Docket: NRC-2019-0155

Reactor Oversight Process Enhancement Initiative

Comments on Reactor Oversight Process Enhancement Initiative NRC-2019-0155

Figure 1. CDF by plant type

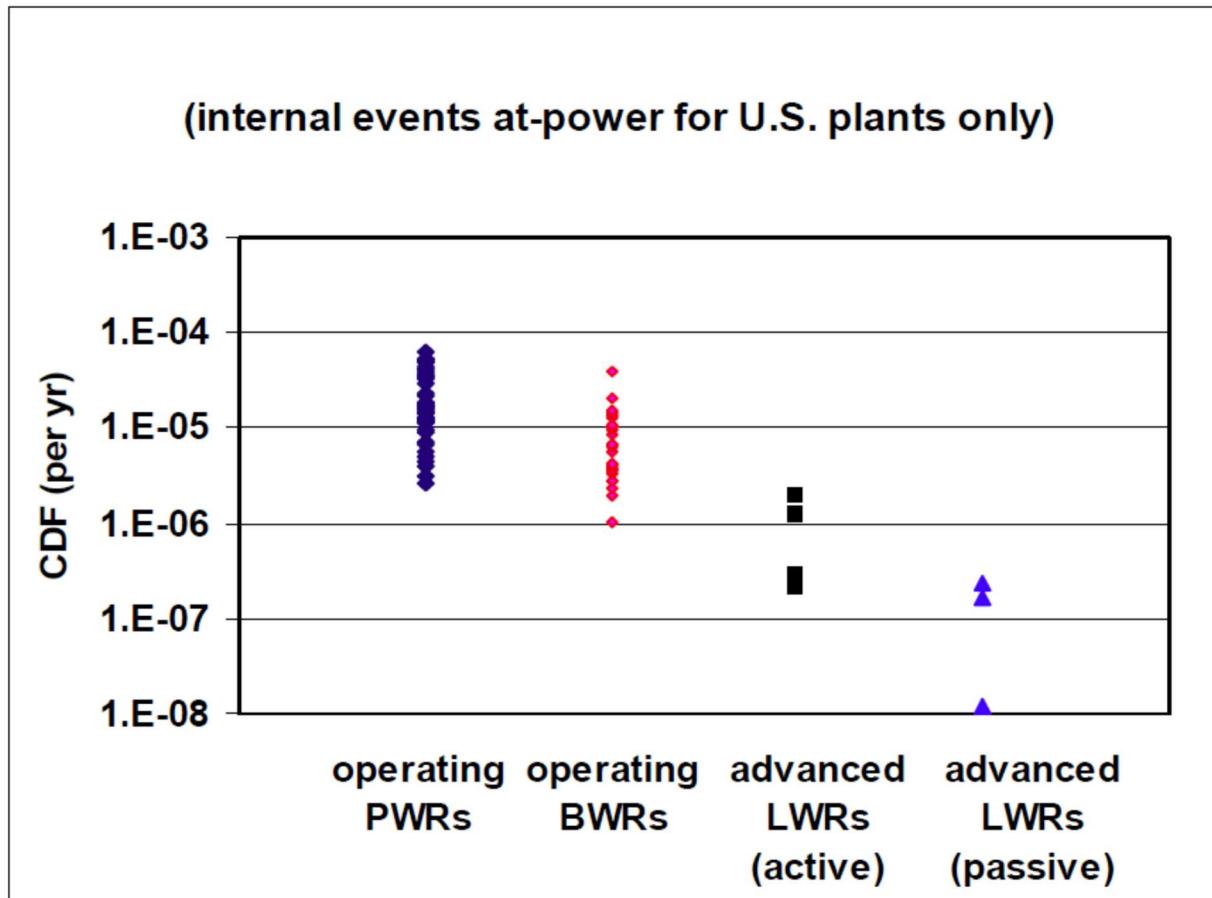
The stack of data points for operating PWRs and BWRs reflects the results for individual operating reactors. For each of these two operating reactor types, the difference between the highest CDF risk and lowest CDF risk is nearly two orders of magnitude (i.e., a factor of 100). That’s about the difference between the lowest CDF risk for existing reactors and highest CDF risk for new reactors. In other words, a risk difference large enough to prompt revamping the Baseline Inspection Program for new reactors is not sufficient to revamp the Baseline Inspection Program for reactors actually operating in communities.

Figure 2. Fire CDF (at-power only)

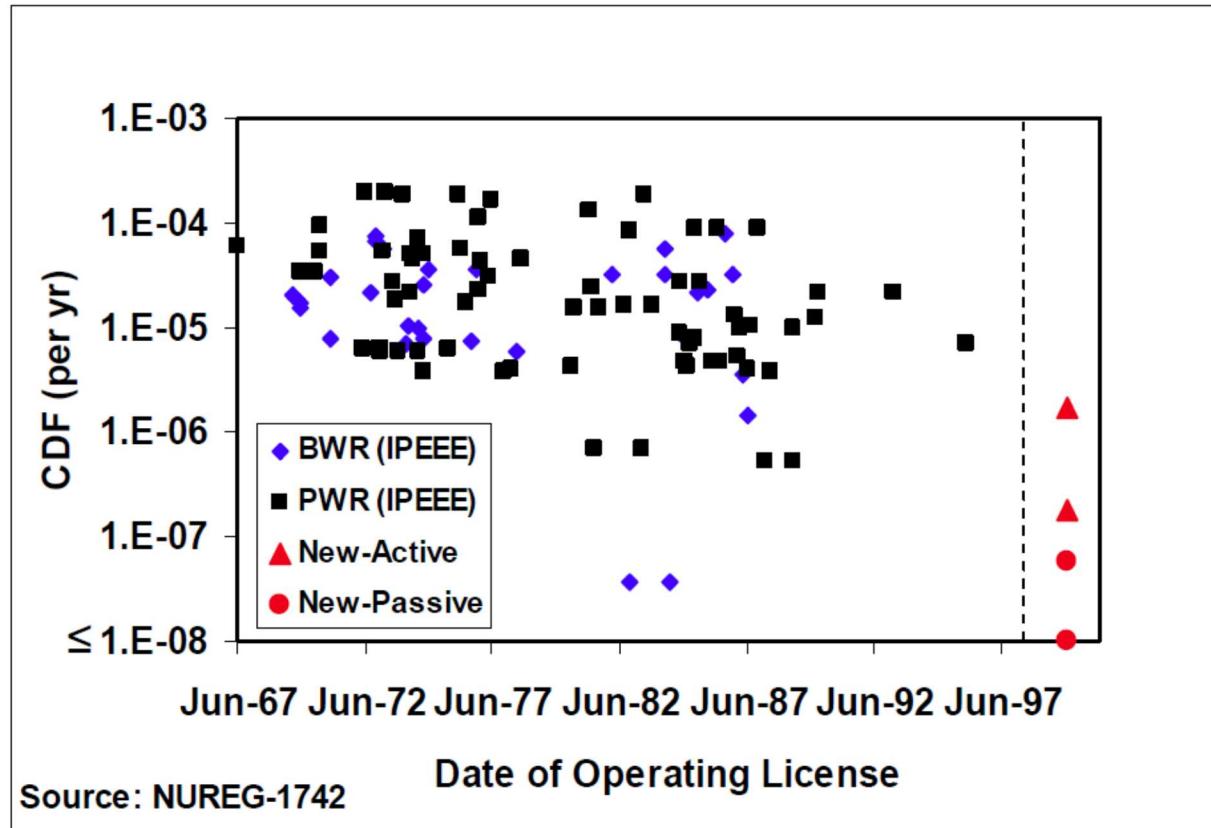
The gap between the highest CDF risk and lowest CDF risk posed by fire is nearly four orders of magnitude—a factor of about 10,000.

Figure 4. LRF by plant type

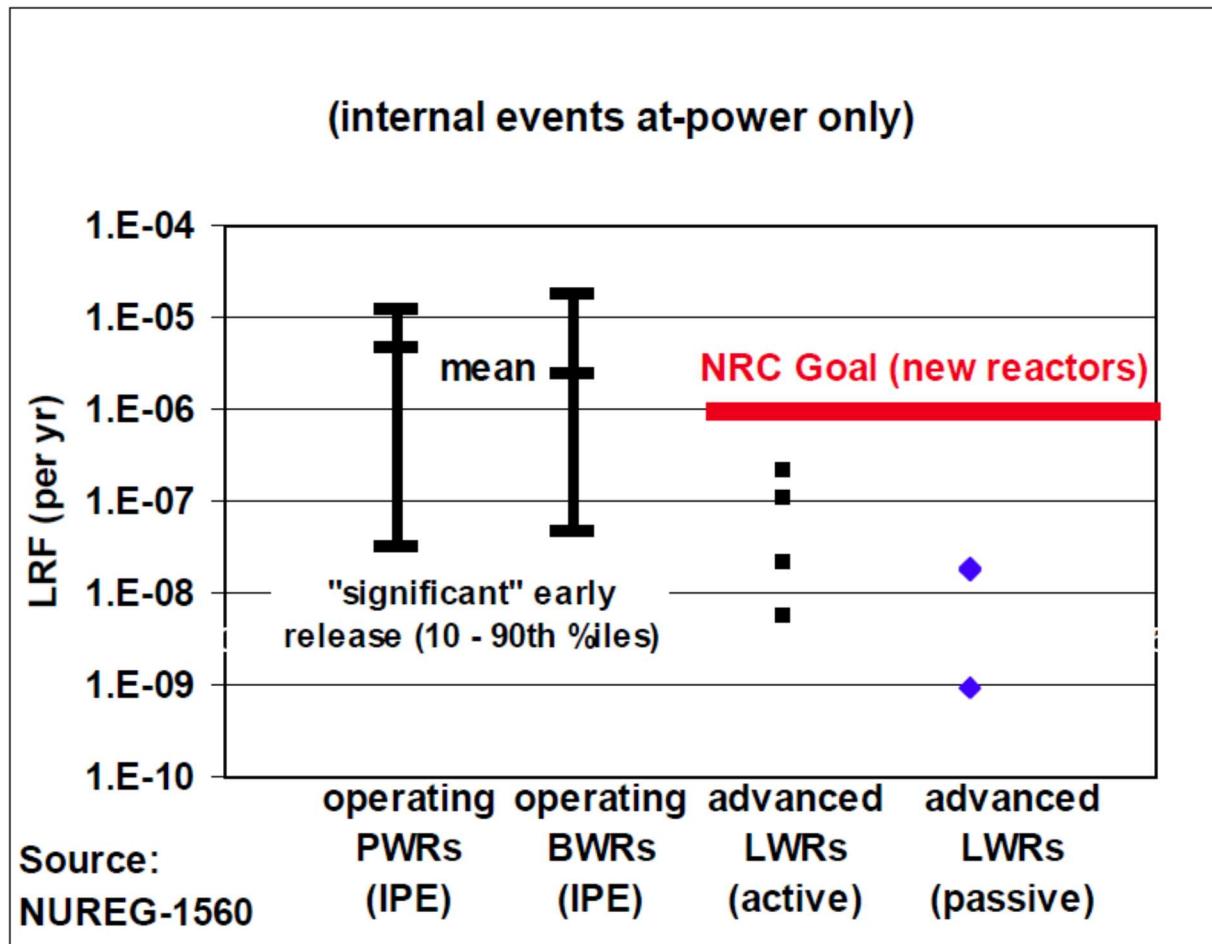
Dr. Dube's data indicates that some of the PWRs and BWRs operating today have LRFs greater than the NRC's safety goal.

The point of all this is to question why the NRC staff would cite design differences in AP1000s that reduce their risk profile in recommending significant reductions in the baseline inspection program effort, but not cite design differences in existing reactor designs to recommend better tailoring of the baseline inspection program effort to actual, real reactor risks.
